LiDAR Quality Assessment Report

UT_BoxElder_2018

Project: UT_BoxElder_2018

Contractor: Aero-Graphics, Inc.

Tile# w1365n2212 Bridge

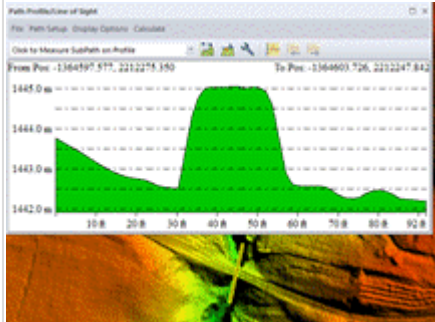
☐ Bridges/Overpasses are properly removed

3 calls on Bridges that require attention

DEM Review calls were accepted with corrections
